**SITE INSTRUCTION NO. ME-13**  
**MECHANICAL AND ELECTRICAL**

**Project Name:** Carleton Place Arena  
75 Neelin Street  
Carleton Place, Ontario

**Project No.:** 205  
**Date:** 2021 February 17

M13.1 Supply & Return Air to Ground Floor Staff Room:

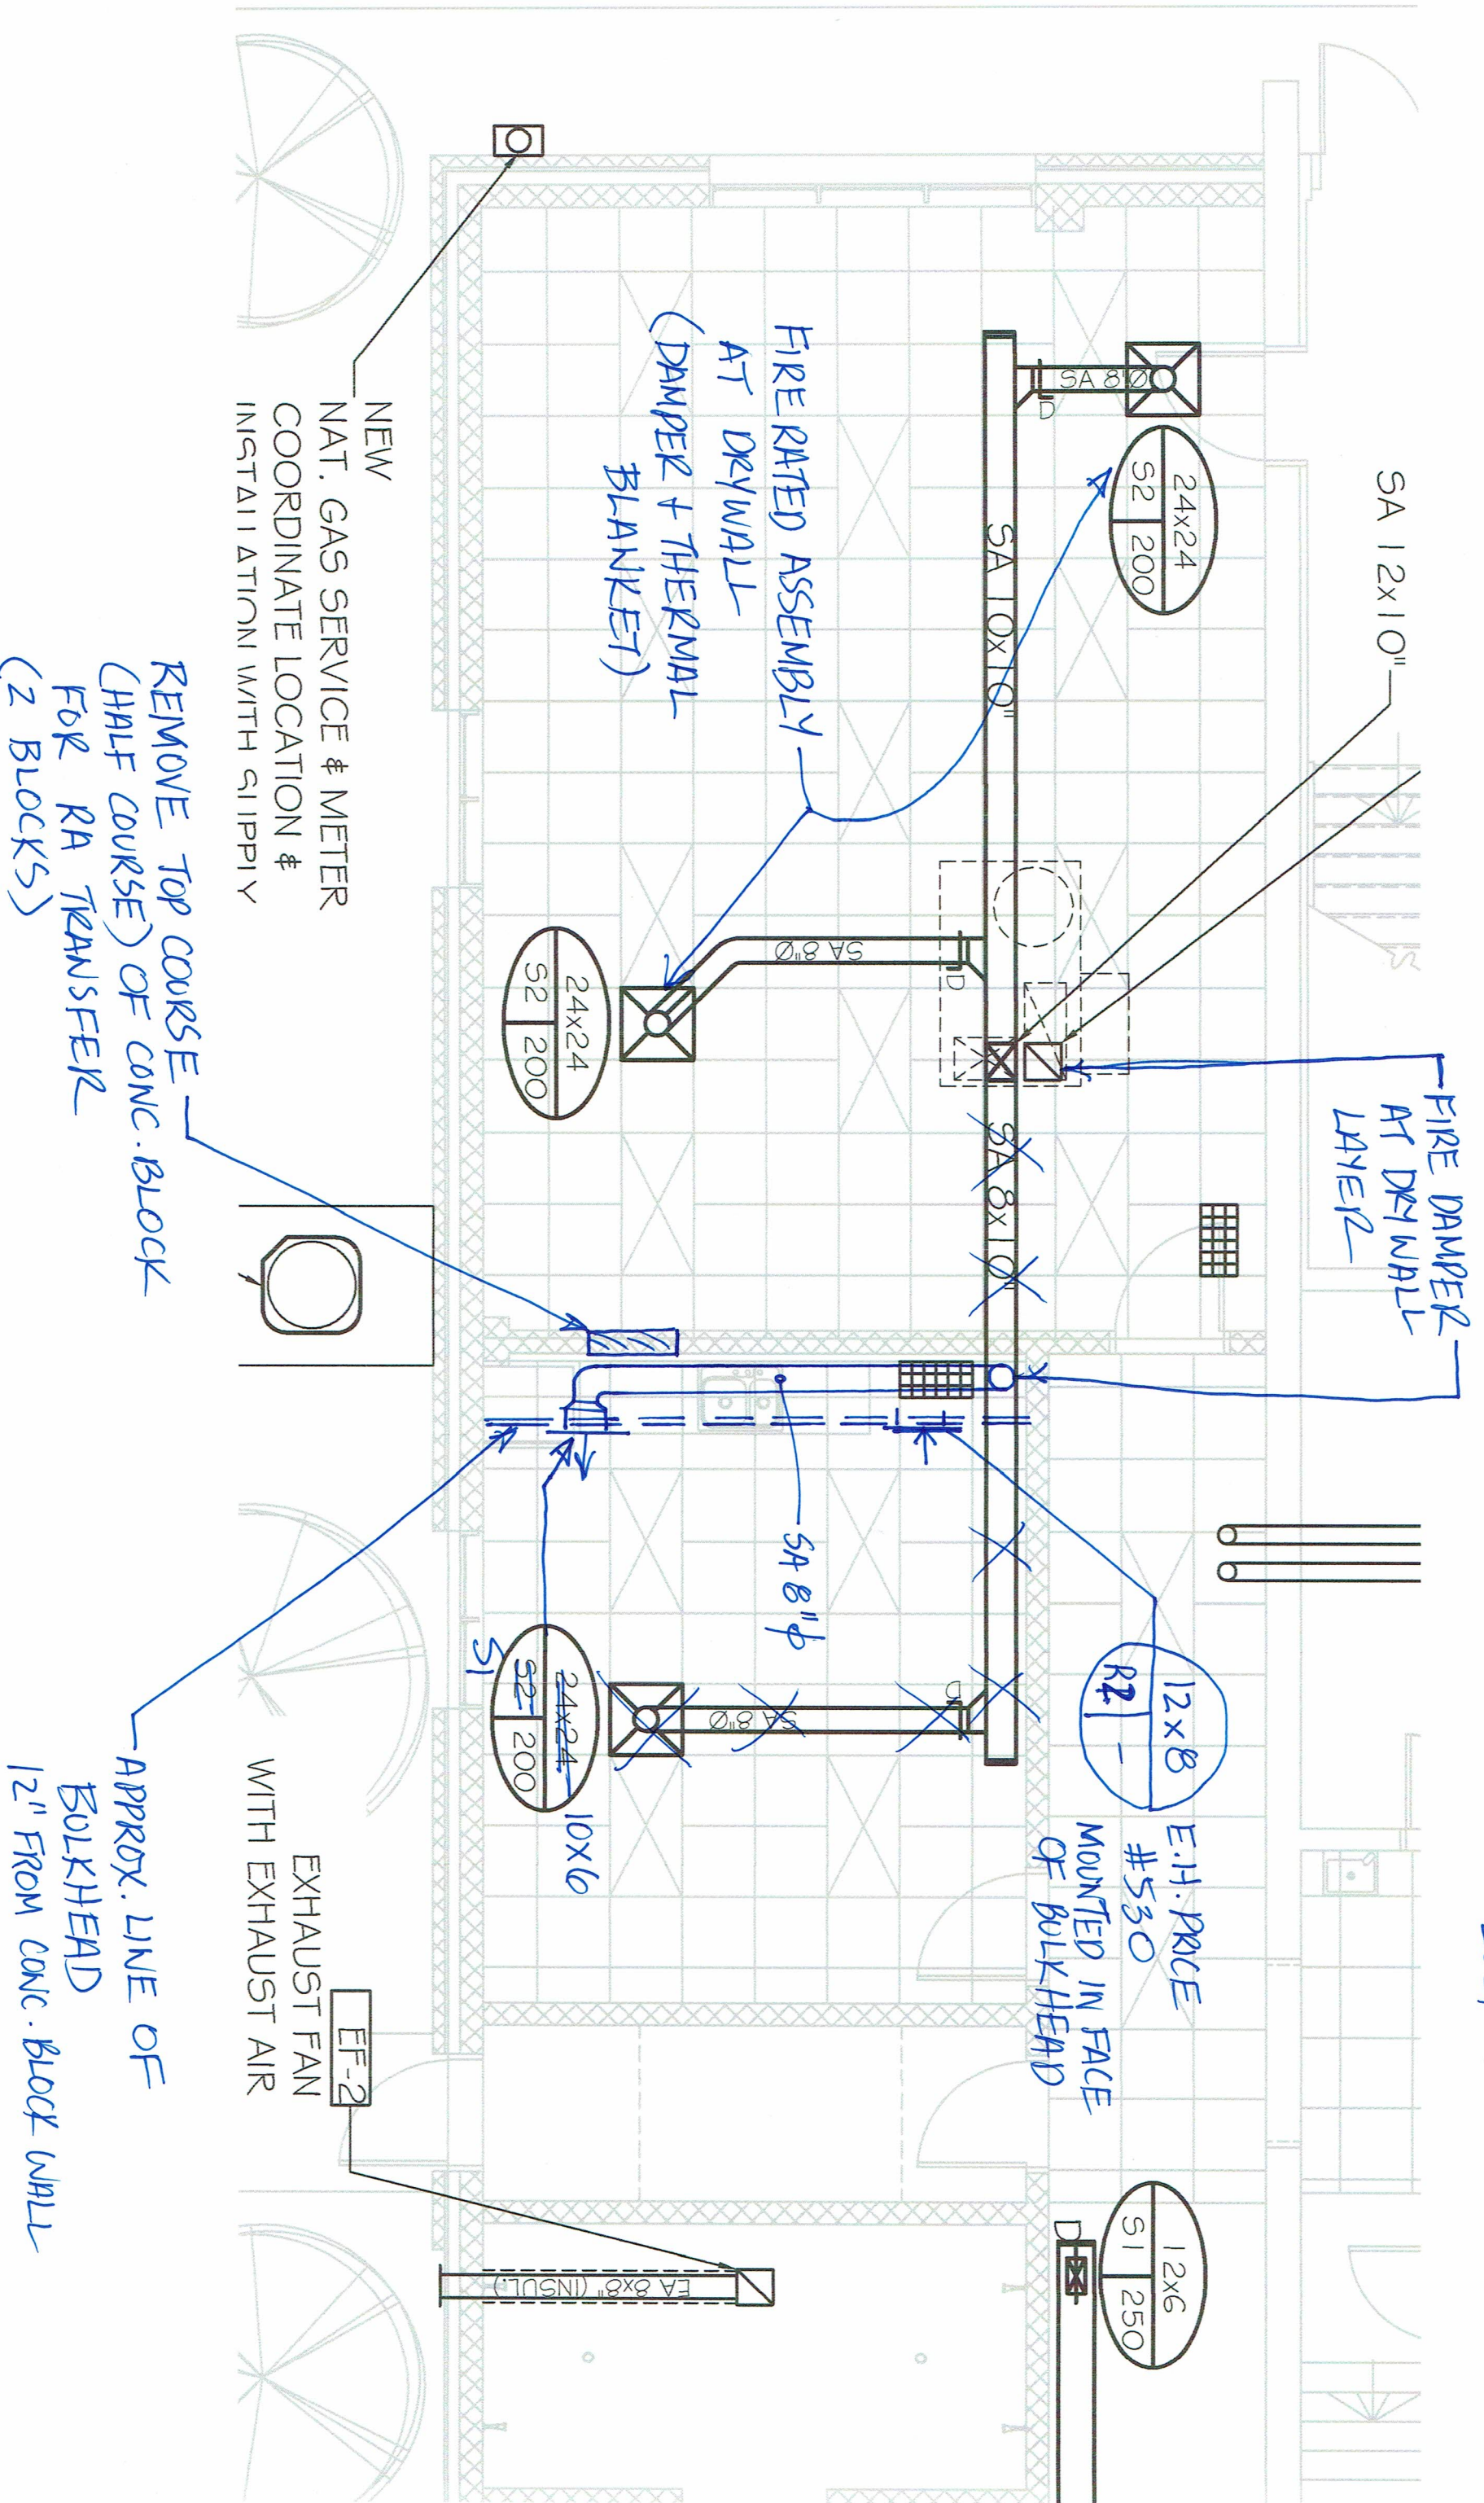
Supply and install Supply Air & Return Air duct to Ground Floor Staff Room, with fired dampers and fire-rated assemblies, in accordance with the attached sketch (1 sketch).

FIRE RATED ASSEMBLY  
AT DRYWALL  
(DAMPER + THERMAL  
BLANKET)

FIRE DAMPER  
AT DRYWALL  
LAYER

12x8  
E.H. PRICE  
#530  
MOUNTED IN FACE  
OF BULKHEAD

REMOVE TOP COURSE  
(HALF COURSE) OF CONC. BLOCK  
FOR RA TRANSFER  
(2 BLOCKS)

APPROX. LINE OF  
BULKHEAD  
12" FROM CONC. BLOCK WALL
